DEPARTMENT OF BIODIVERSITY, CONSERVATION AND ATTRACTIONS REPORT

PROPOSAL	Redevelopment of Existing Boatshed for Wesley College and Penrhos College
LOCATION	Portion of Lot 11835 on Plan 240379 (Reserve 34565) and Lots 778 on Plan 163503 and 780 on Plan 91394 Coode Street, South Perth
COST	\$2,400,000
APPLICANT	Rowe Group on behalf of Wesley College and Penrhos College
LANDOWNER	Land under the care, control and management of the City of South Perth
LOCAL GOVERNMENT	City of South Perth
MRS CLASSIFICATION	Parks and Recreation Reserve
DECISION TYPE	Part 5, <i>Swan and Canning Rivers Management Act 2006</i> , Ministerial Determination
ATTACHMENTS	<ol style="list-style-type: none"> 1. Development Proposal <ol style="list-style-type: none"> 1.1 Initial Development Proposal – Plans, Visual Representation and Landscape Concept 1.2 Amended Development Proposal 2. External referral responses: <ol style="list-style-type: none"> 2.1 – 2.3 City of South Perth 2.4 Department of Water and Environment Regulation 2.5 Department of Planning Lands and Heritage – Land Management 2.6 Department of Planning Lands and Heritage – Heritage Services 2.7 Department of Planning Lands and Heritage – Aboriginal

Figure 2: Demolition plan showing existing boatshed size and location

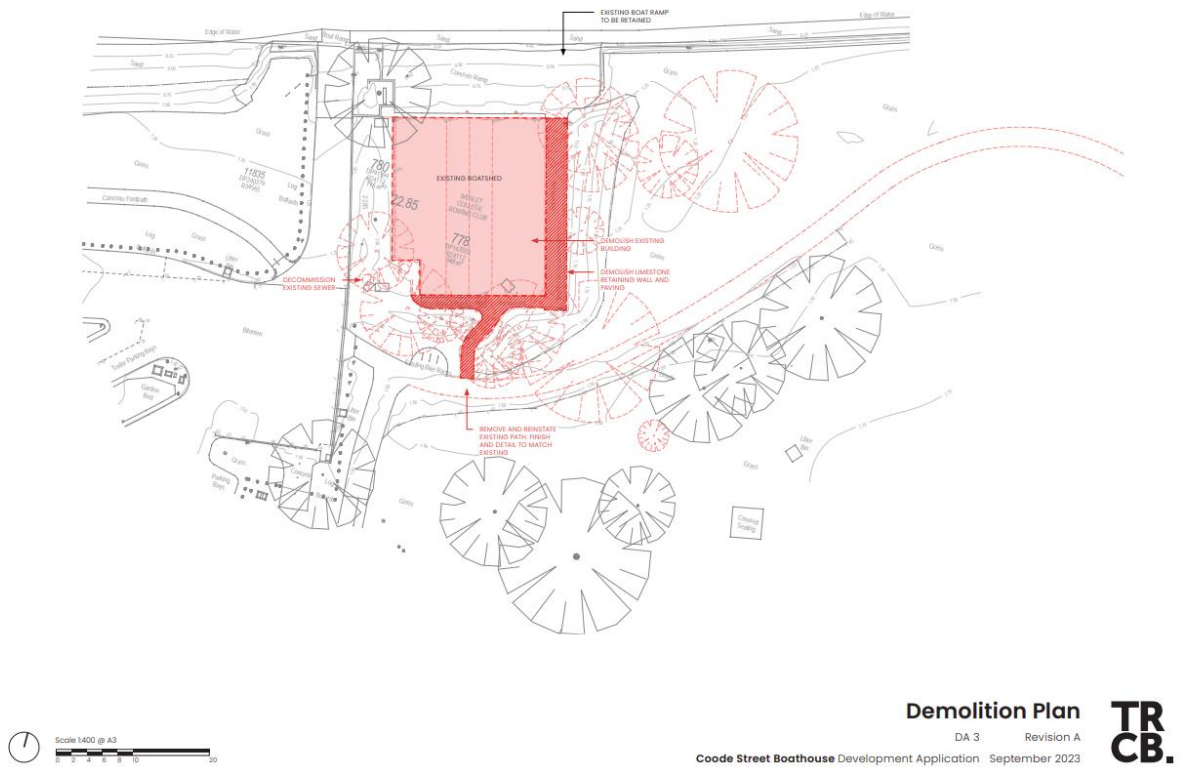
- 6.3 The proposed development includes the removal of existing mature vegetation, including eight mature trees. This has been substantially reduced from the initial proposal to remove 13 existing mature trees.

- 6.5 As part of the submission of amended plans the Applicant has provided an Arborist Report. A copy of the Arborist Report is included in **Attachment 4**. This report supported the removal of nine trees. However, the number of trees to be removed has been revised down to eight trees with the increased setback to the proposed boatshed.

Figure 4: Amended site plan detailing foreshore setbacks (28 March 2024)

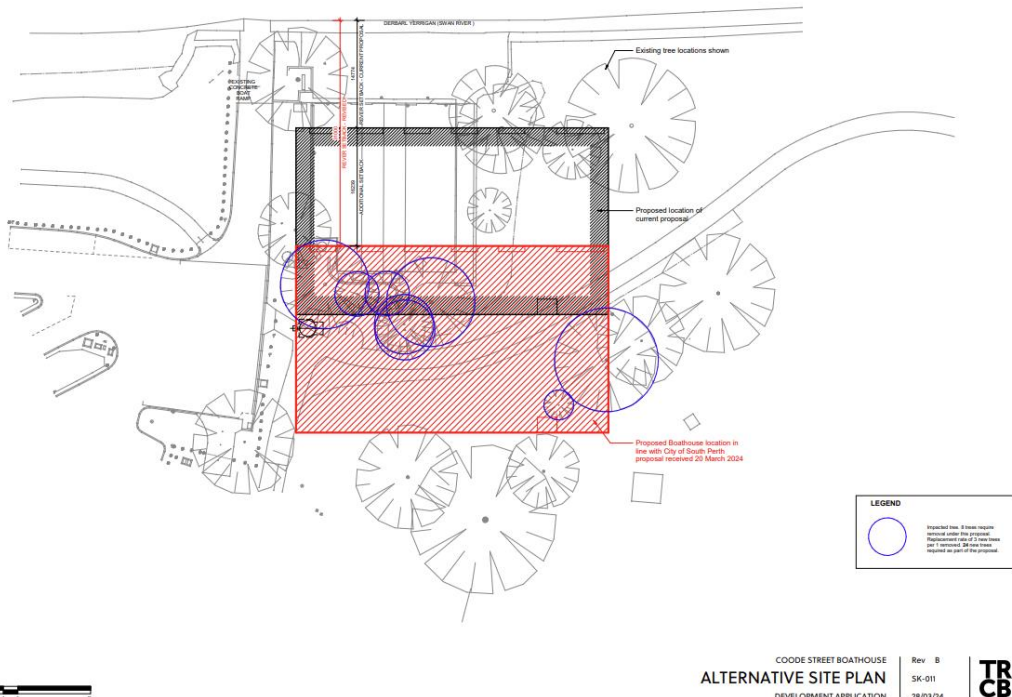
5.9 As part of later negotiations between DBCA, the colleges and the City regarding the consideration of amended plans, the setback of the proposed boatshed has been increased from 12.75m to 31m (refer Figure 4). The amended design includes relocation of the pedestrian access along the foreshore between the river and the proposed boatshed as well as planting around the site to soften the visual impact of the boatshed.

- 6.32 Discussions between DBCA, the colleges and the City in March 2024 resulted in the submission of a concept plan on 28 March 2024 that propose an increased setback of 31m to the proposed boatshed.

- 6.47 The Applicant submitted an amended concept plan on 28 March 2024 that illustrated an increased setback of 31m to the proposed boatshed.
- 6.48 The increased setback will enable the future foreshore enhancement works to respond to the principles and objectives of Perth Water Buneenboro Locality Plan, SPP2.10 and Policy 42. The City's aspirations to provide a softer foreshore interface that facilitates community access to the river along with providing greater environmental benefits can also be achieved with this design modification.

Figure 5: South elevation detailing proposed building materials (view from playground/family picnic area)

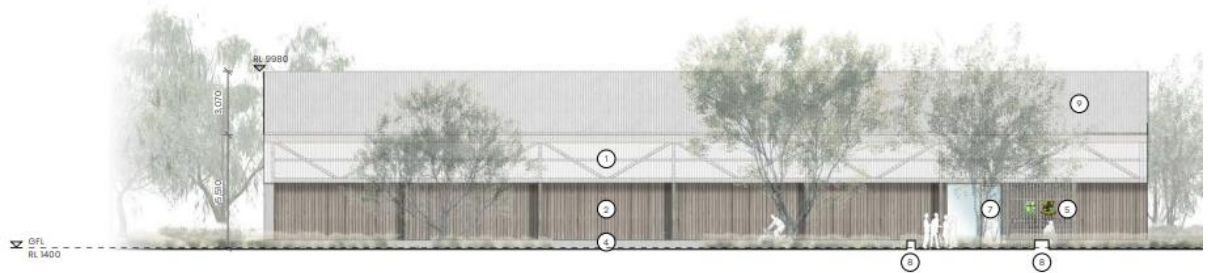
- 5.10 The boatshed is proposed to be constructed of blackened hardwood cladding and metal roller doors for the walls, corrugated polycarbonate sheeting and colorbond metal roofing (shale grey) for the roof structure (refer **Figure 5**).
